HOPE CREEK GENERATING STATION
DOCKET NO. 50-354
DRAFT SAFETY EVALUATION REPORT
OPEN ITEM STATUS

Attachment 1 is a current list which provides a status of the open items identified in Section 1.7 of the Draft Safety Evaluation Report (SER). Items identified as "complete" are those for which PSE&G has provided responses and no confirmation of status has been received from the staff. We will consider these items closed unless notified otherwise. In order to permit timely resolution of items identified as "complete" which may not be resolved to the staff's satisfaction, please provide a specific description of the issue which remains to be resolved.

In addition, enclosed for your review and approval (see Attachment 4) are the resolutions to the Draft SER open items and the resolution of comments received during the April 17 and 18, 1984, Power Systems Branch (Mechanical) meeting on the 430 questions series, listed in Attachment 3. A signed original of the required affidavit is provided to document the submittal of these DSER open item and FSAR question responses.

FIGURE B-3-16
SHEET 1 OF 8

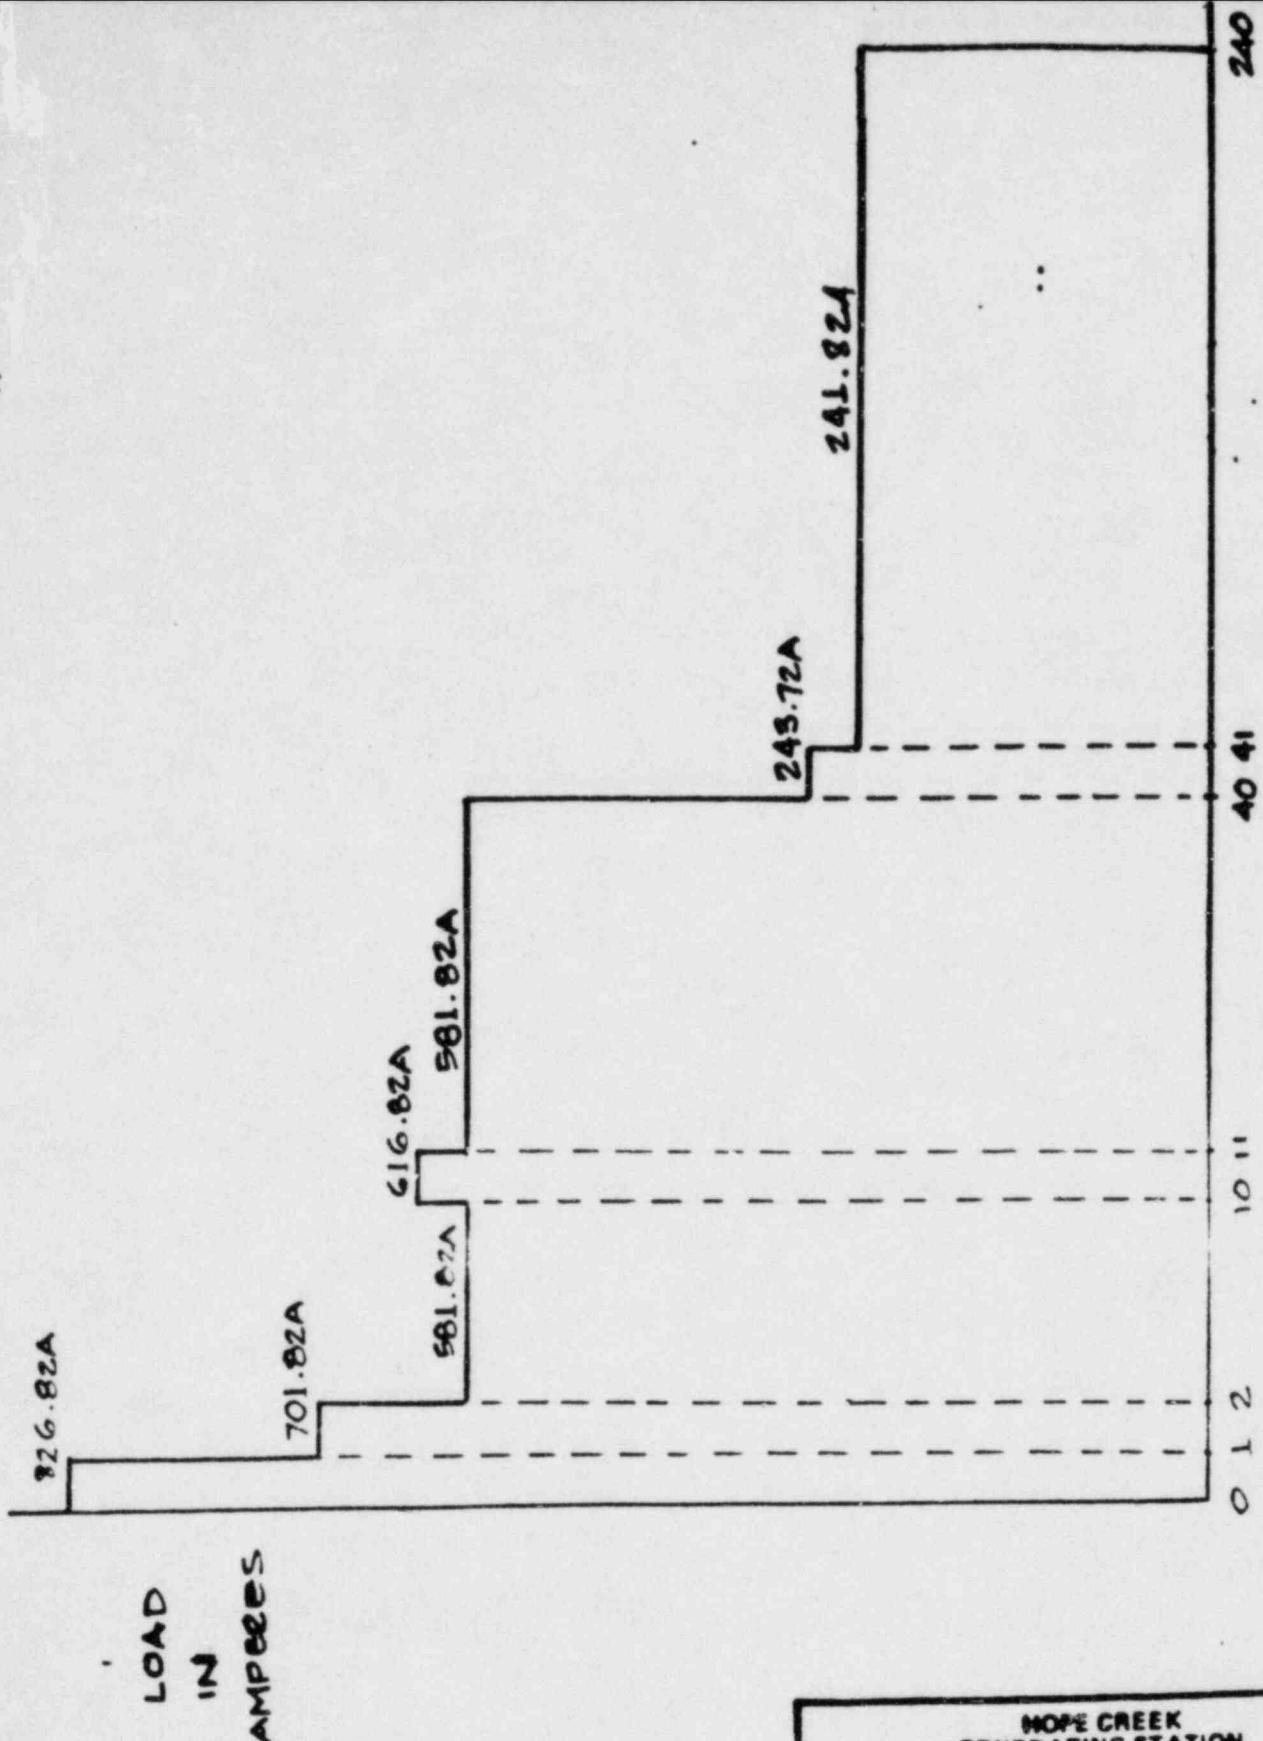
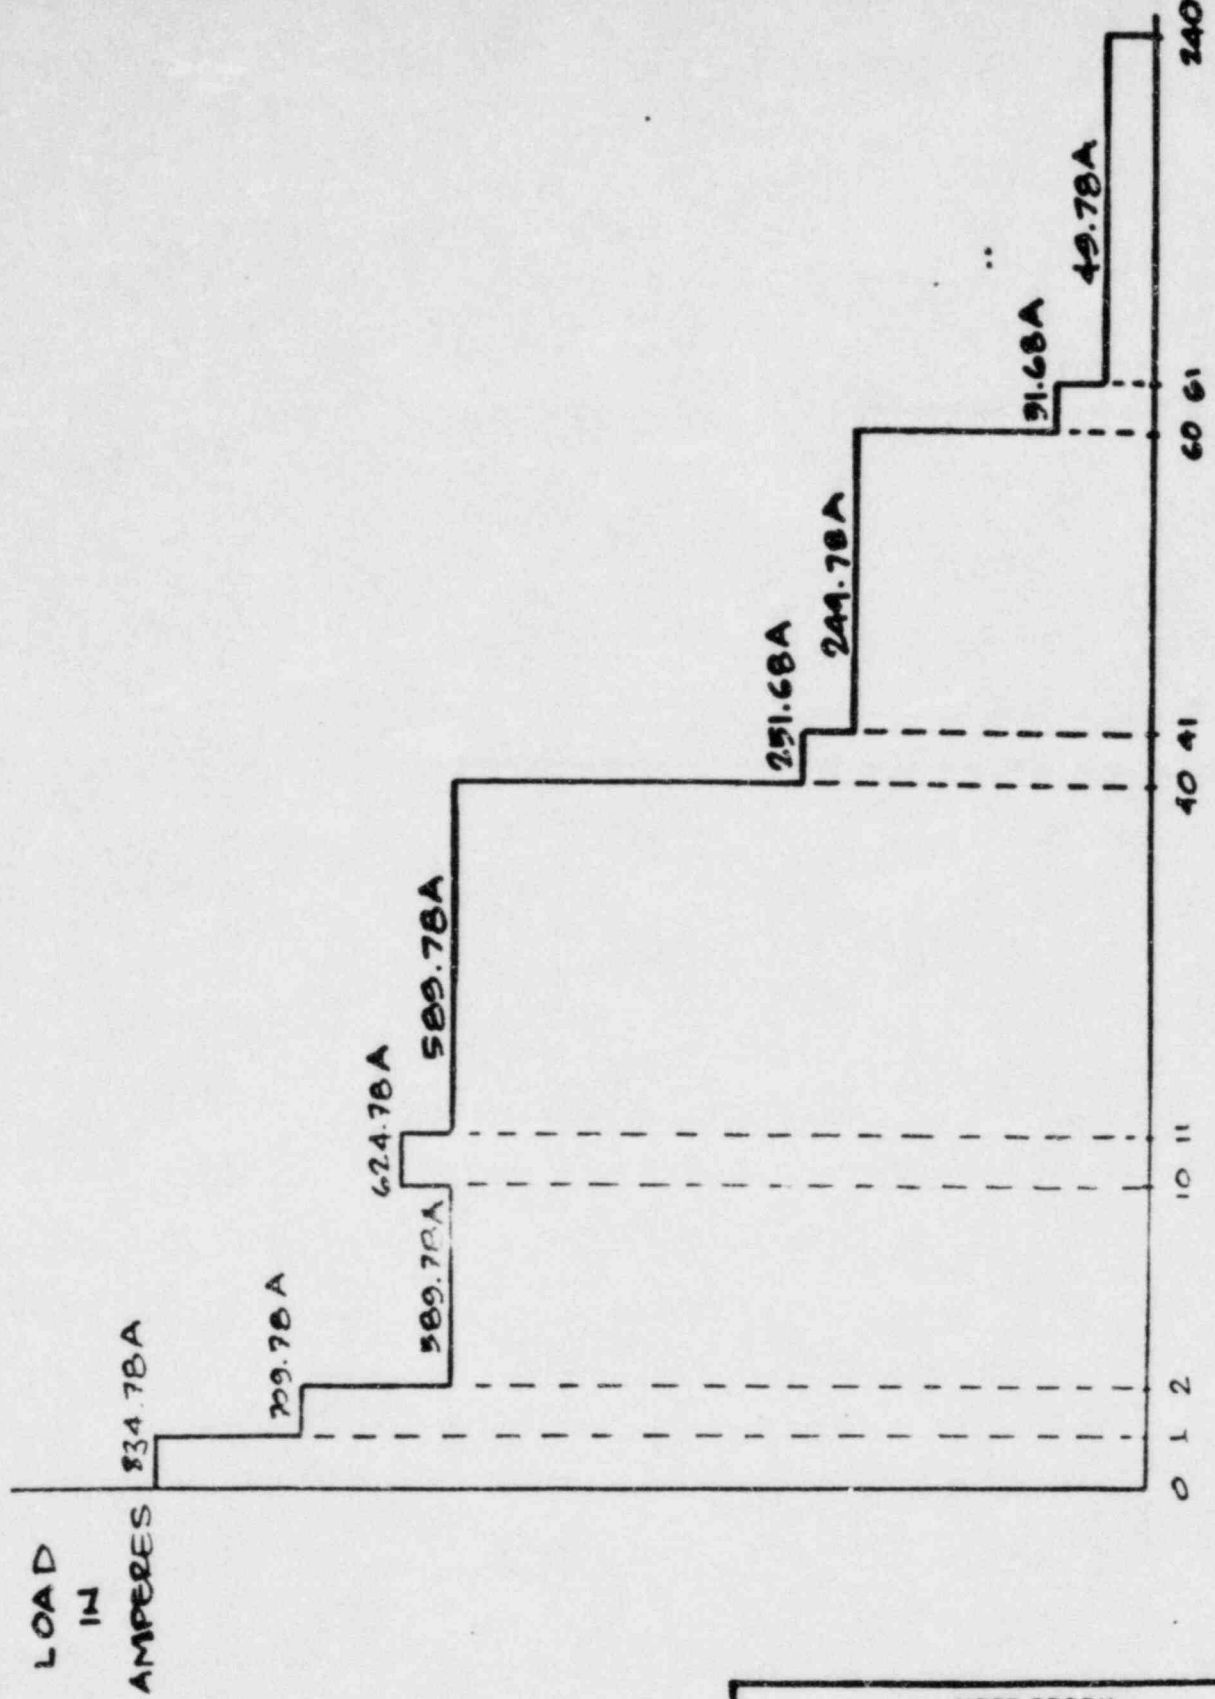
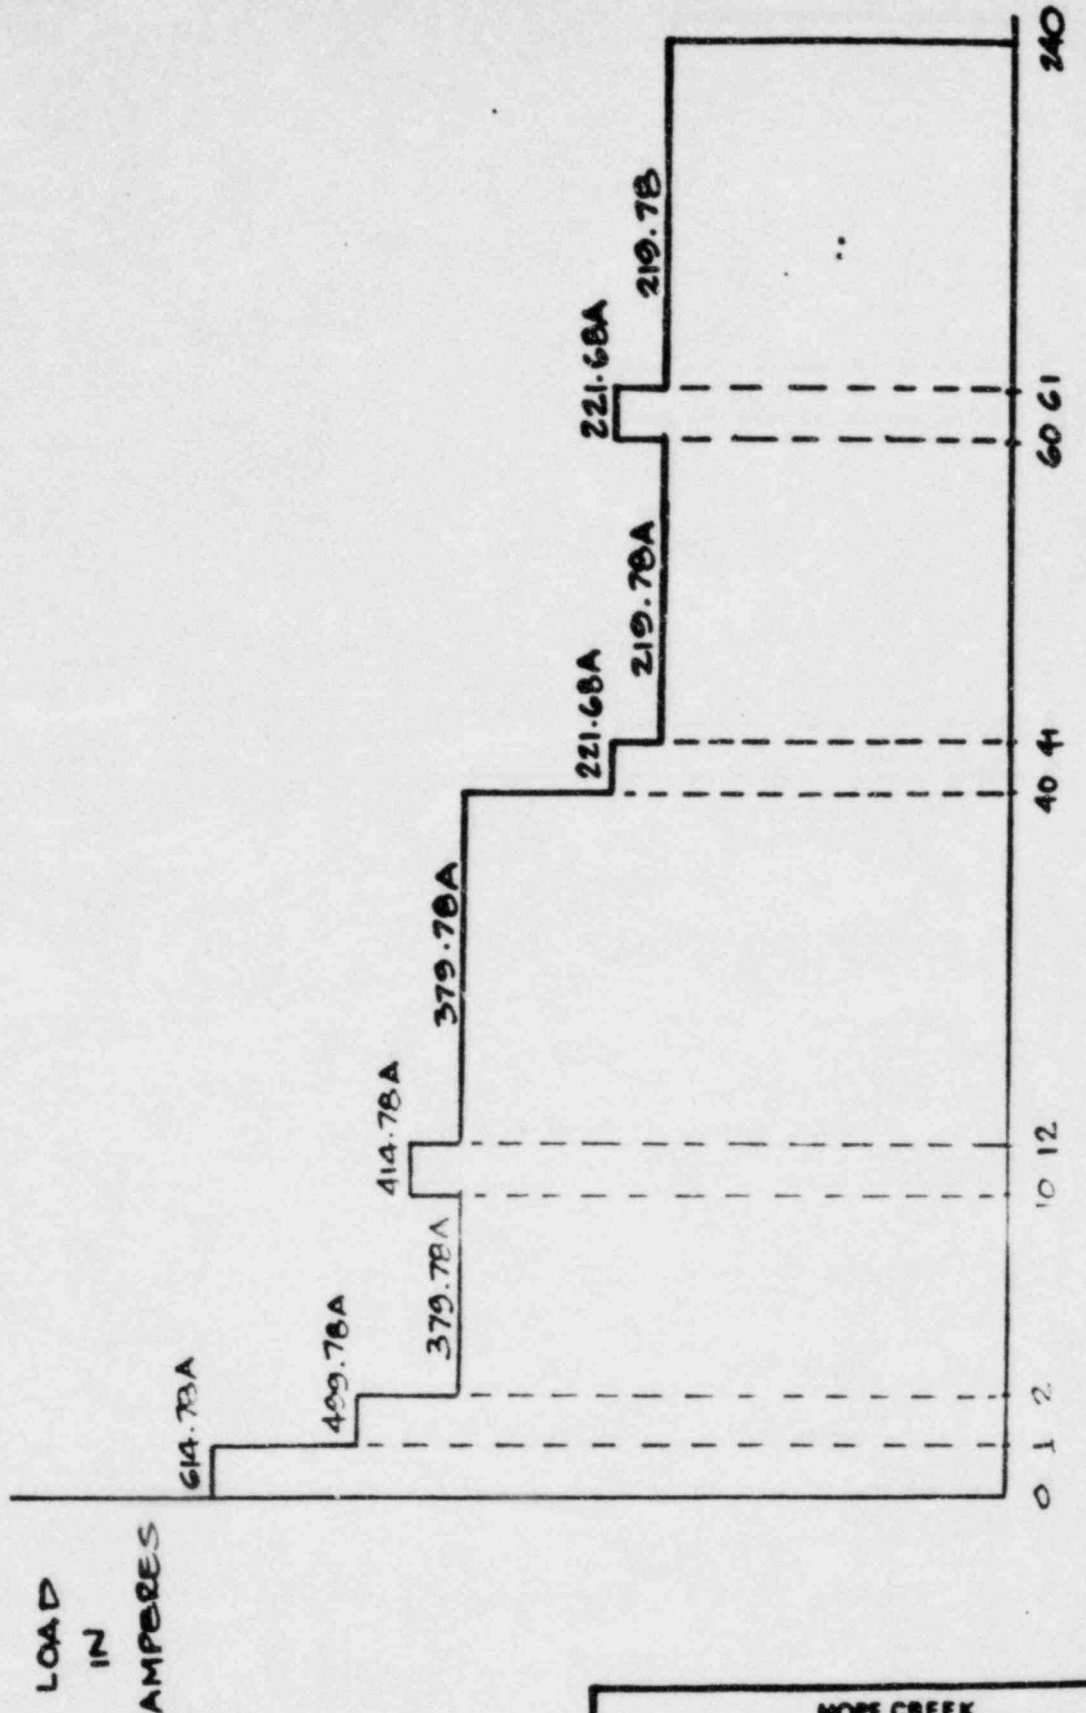
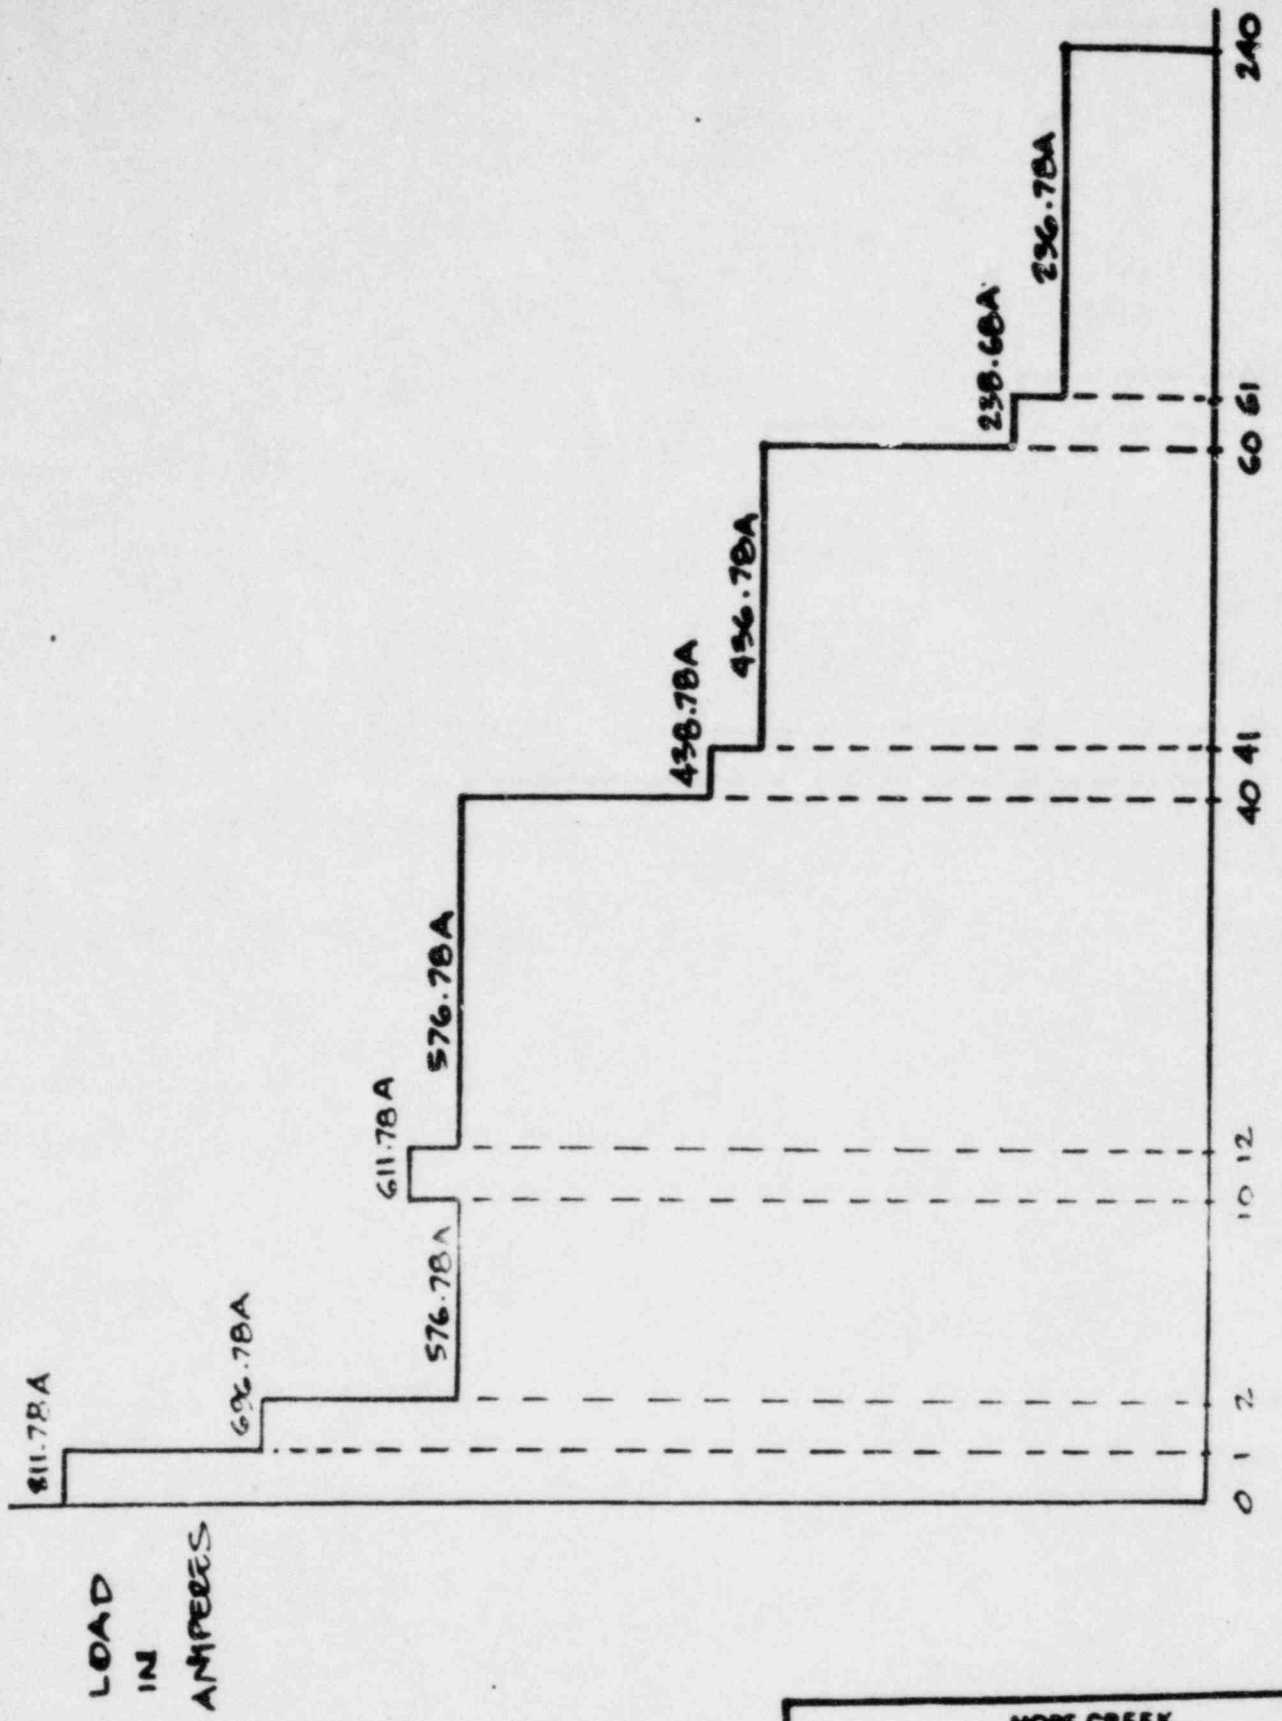
RESPONSE

Tables 8.3-7a,b,c, and d, have been revised to change the 13 seconds to 1 minute.
